Te Hui o Te Kaunihera ā-Rohe o Heretaunga
Hastings District Council
Hearings Committee Meeting

(Oderings Nurseries CHCH Limited - 55 and 57 Brookvale Road, H Nth)

2. ODERINGS NURSERIES CHCH LIMITED - RESOURCE CONSENT APPLICATION FOR RESIDENTIAL DEVELOPMENT OF 55 AND 57 BROOKVALE ROAD, HAVELOCK NORTH (RMA20230145)

Application for Resource Consent: 55 Brookvale Road, Havelock North, RMA20230145

Figure 4: Lot 31 Outdoor Living Space (3.9m Diameter Circle Achieved)

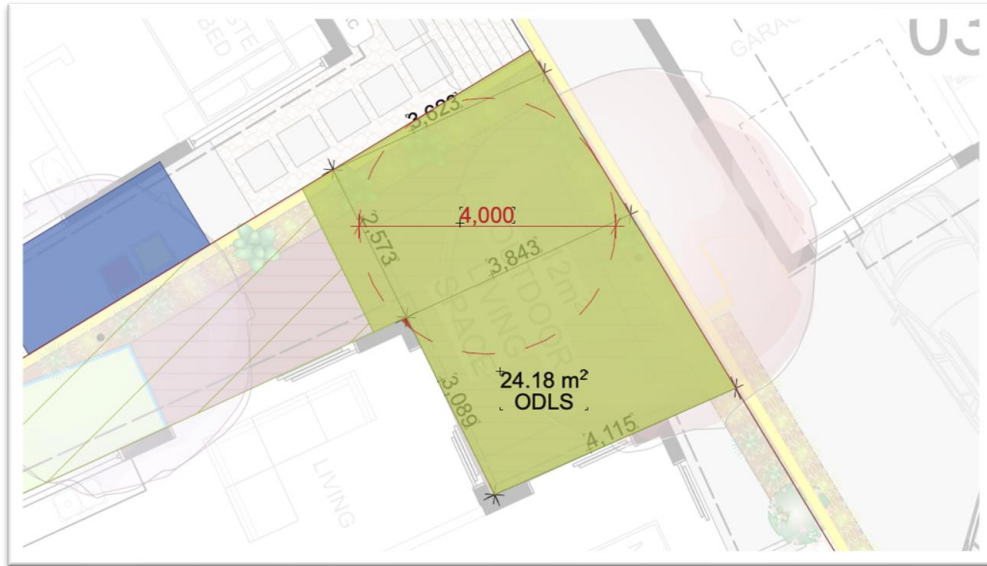
14. Lot 31 infringe standard 8.2.6.F(4)(b) as a 4m diameter circle cannot be accommodated within the ODLS. As assessment of the effects has been provided below, which we suggest results in a less than minor effect:

- a. Lot 31 can support a 3.9m diameter circle within the ODLS. The ODLS circle infringes the standard by 0.1m, due to the corner of the living room.
- b. The onsite amenity for residents is not likely to be materially affected by this infringement because:

DRAWING NO	REVISION	DATE
A106	A	11/07/2023

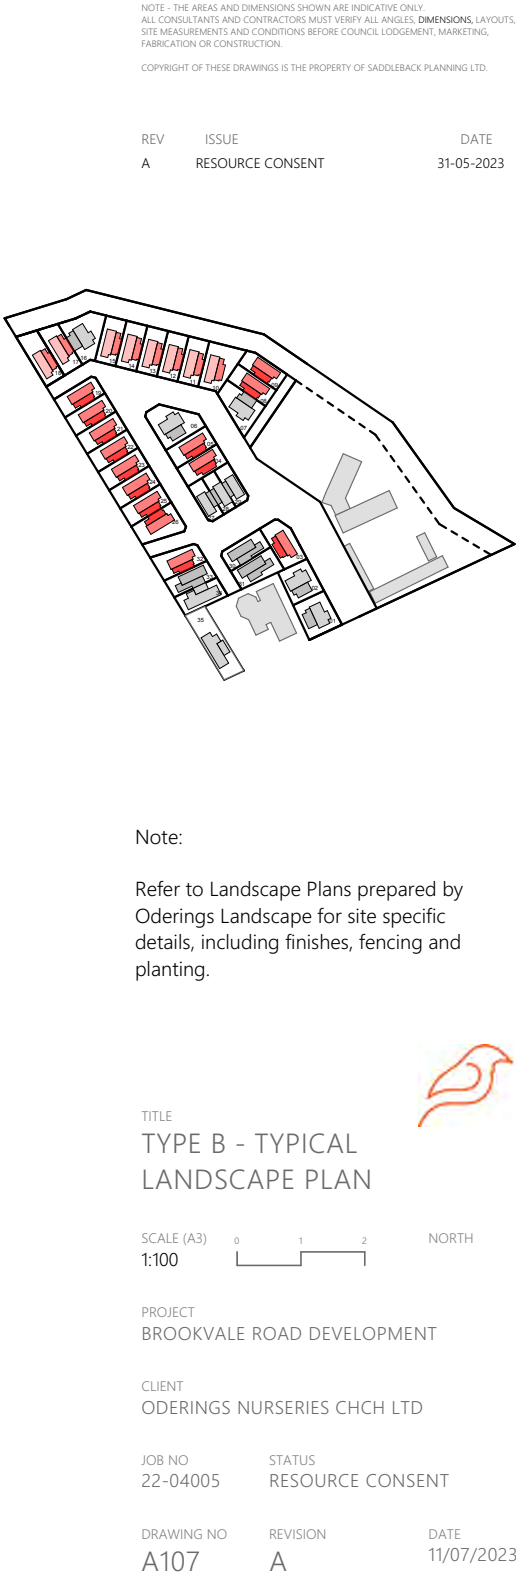
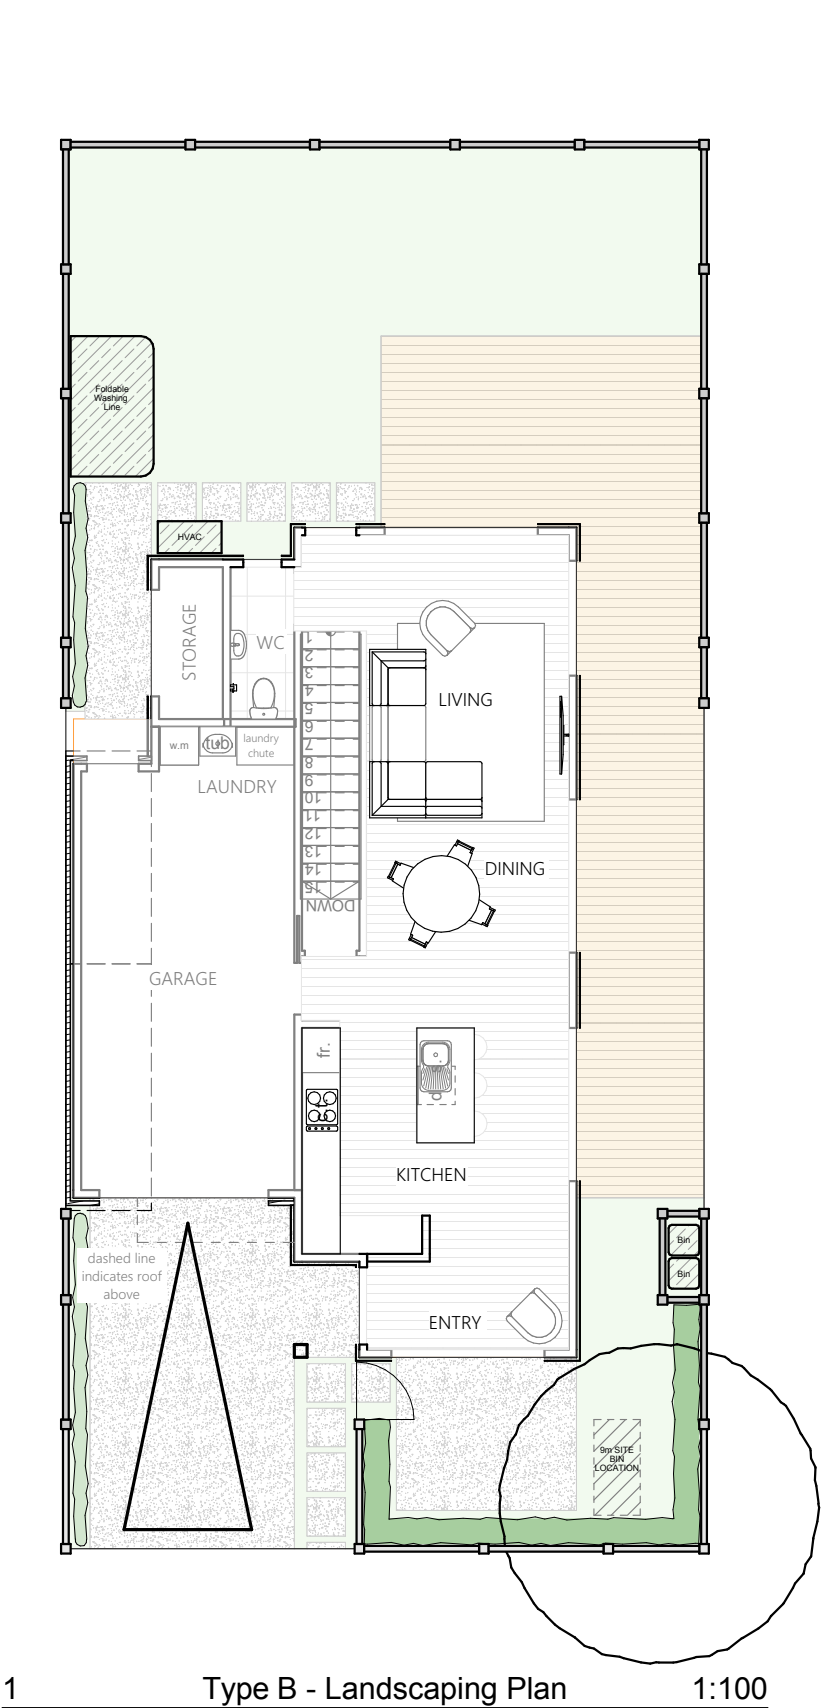
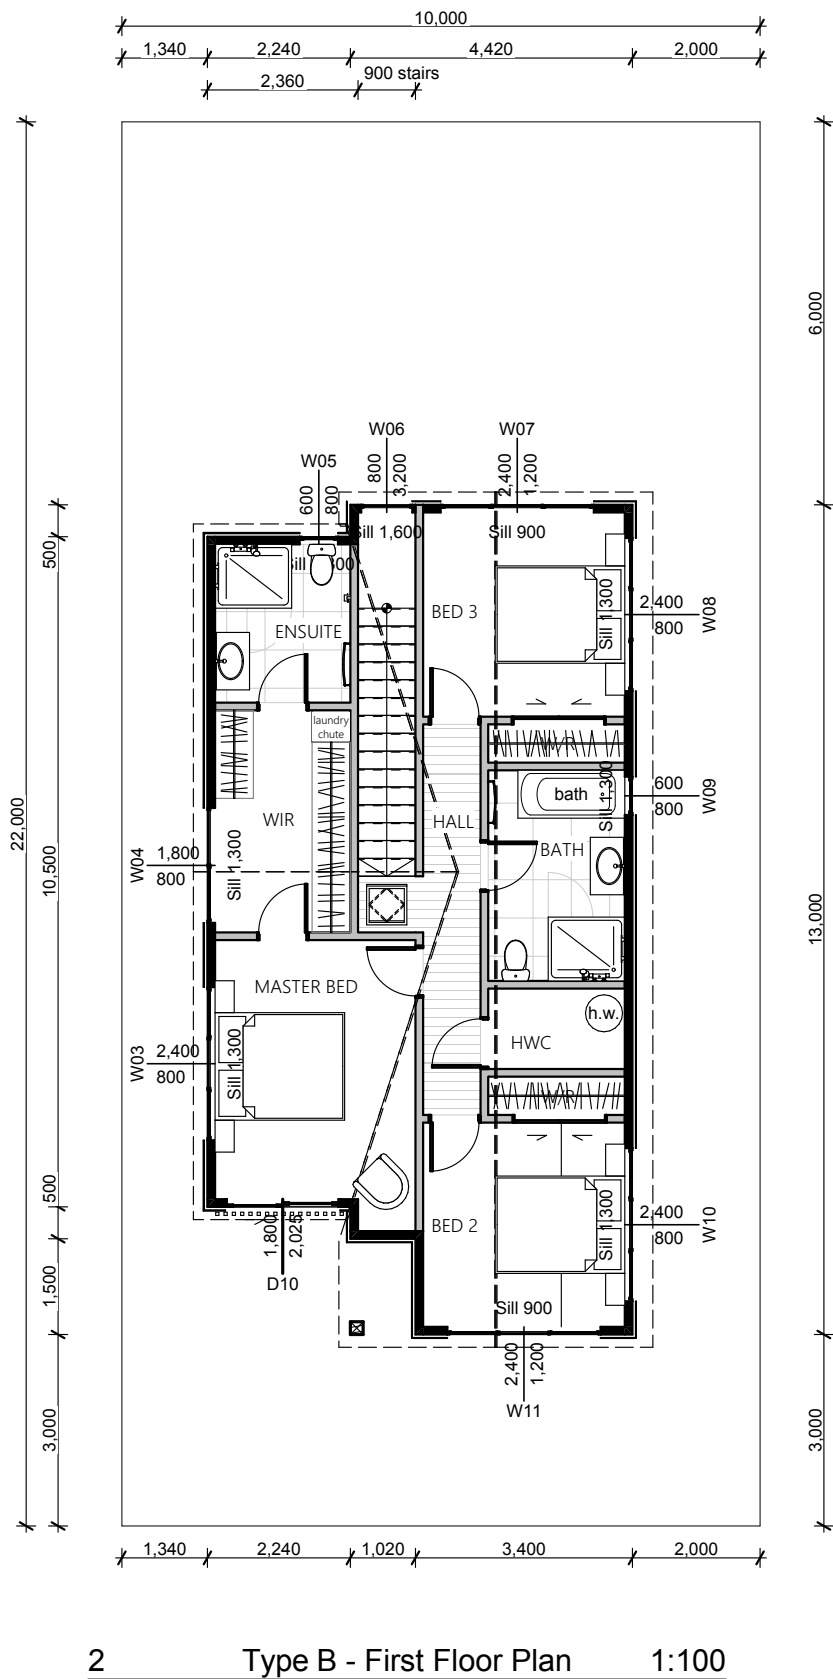
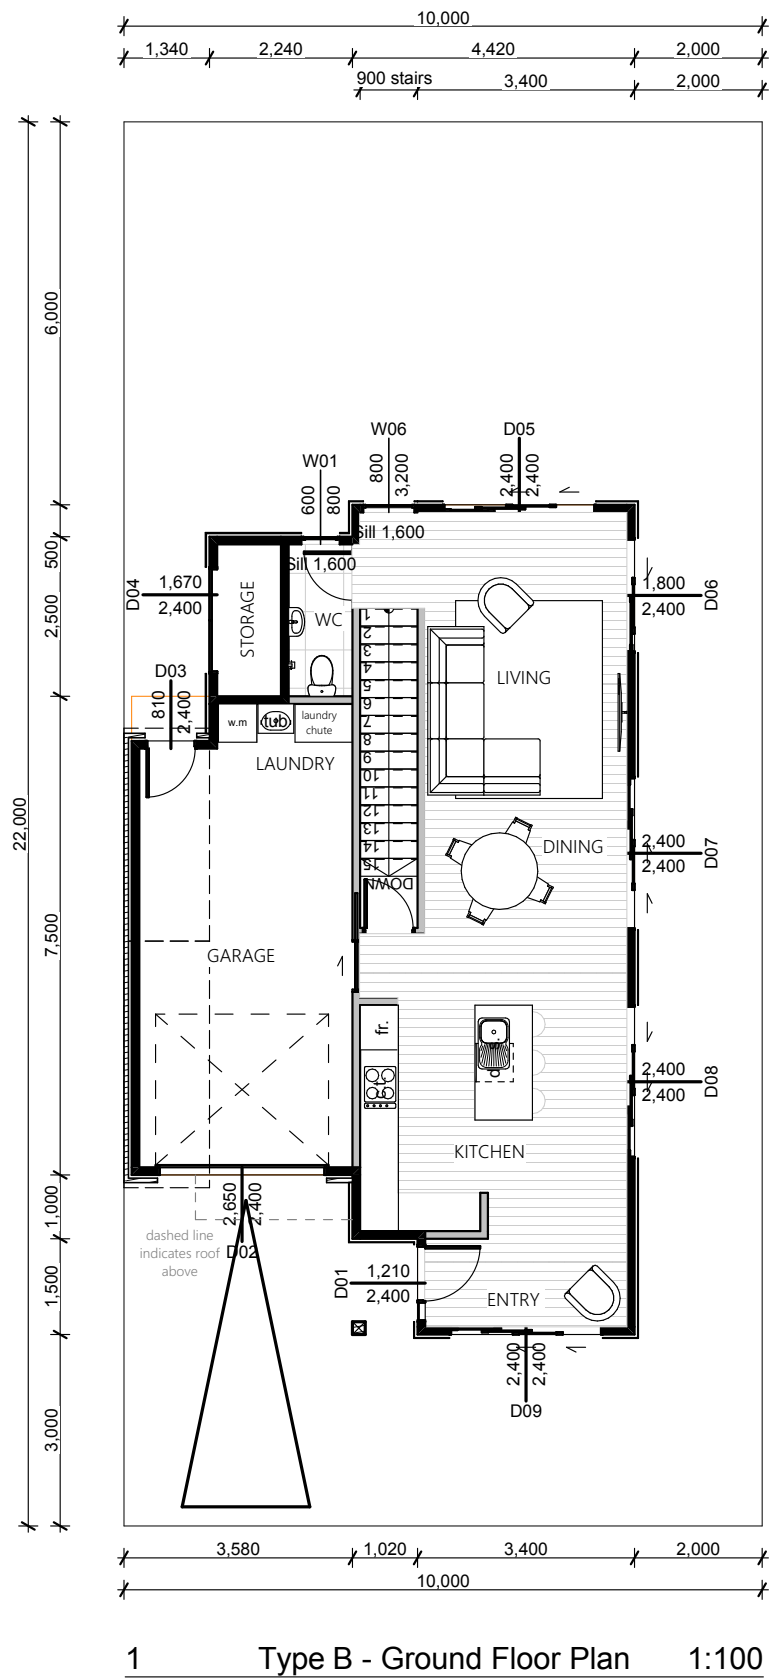
- d. **Typology A** – Please review the zero lot boundary features for Type A (i.e. proposed Lots 7 & 16) as there is a window to the side wall (refer E2, drawings A105 and A106). Please provide updated drawings.

Please review the zero lot boundary features for Type A (i.e. proposed Lots 7 & 16) as there is a window to the side wall (refer E2, drawings A105 and A106). Please provide updated drawings.

Figure 3: Architectural Plans RFI Response (Sheet A106)
